YAMAHA

PARTS CATALOGUE

GOLF CAR

GOLF CAR 1985

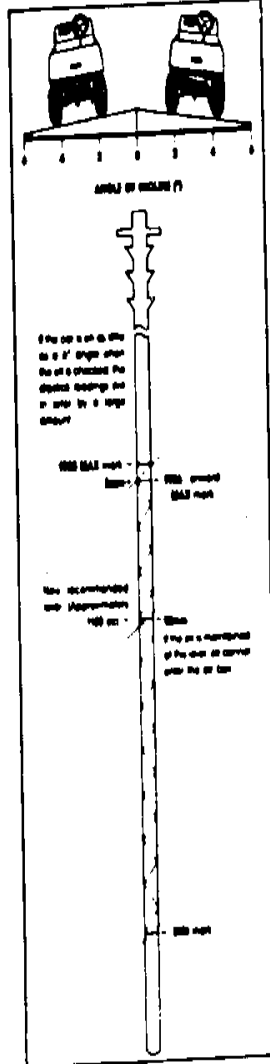
Customers should be cautioned that the oil level should be checked only when the car is on level ground. As seen in the illustration, with the car on as little as a 6° incline (normal road drainage pitch is about 4°), the dipstick can be easily misread.

By reducing the oil level in the engine to approximately 100 cc, this problem will no longer occur.

When adding or changing oil, the engine should be filled with 100 cc of oil. This amount lowers the oil level to a point on the dipstick between the MAX and MIN marks, about one-third the distance below the MAX mark (2mm). Do not fill above this point. This slightly reduced oil level will not affect lubrication. The oil level warning system still gives ample notice when oil must be added.

CORRECT FOR G2-A
NGK B5ES or CHAMPION NR, NGC

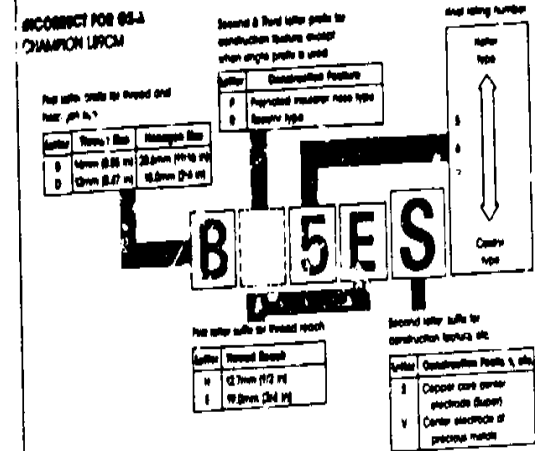
INTRODUCTION
The CHAMPION spark plug used on pages 7-29 and 8-7 in the G2-A Service Manual is incorrect. The correct spark plug has a 3/4" thread reach and not 1/2" as listed in the manual. Performance is adversely affected by using the incorrect spark plug.

HOW TO READ SPARK PLUG I.D. NUMBERS
If replacement of the spark plug is necessary, use the correct type/number/range as listed. Spark plug installation torque is 14 ft lb (2.0 Nm).

G2-A, G3-A	NGK	CHAMPION
G2-A	B5ES	NGC, NR

G2-A/G2-E PRIMARY ID FRAME LOCATION CHANGE

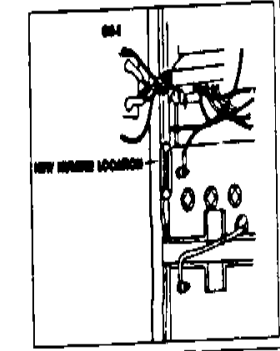
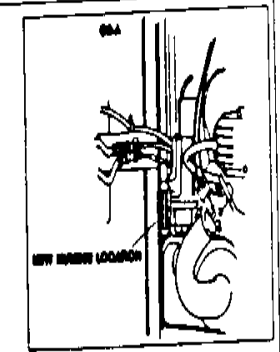
INTRODUCTION
The placement of the stamped-in primary ID number on the vehicle frame has been changed. See the illustrations for the new locations.
NOTE: The G2-A engine number location remains the same.

SERVICE PROCEDURES

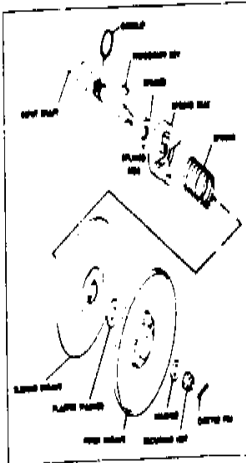
REMEDY Replace the spring seat circlip with the new spacer.

1 Follow service manual instructions to remove the rear body and the secondary clutch fixed sheave.

2 Remove the plastic washer, woodruff key, sliding sheave, and spring seat. Remove the circlip. Tag the circlip with a Warranty Parts tag and hold for 90 days from the date the Warranty Request is submitted. The circlip is not used with the new spacer.
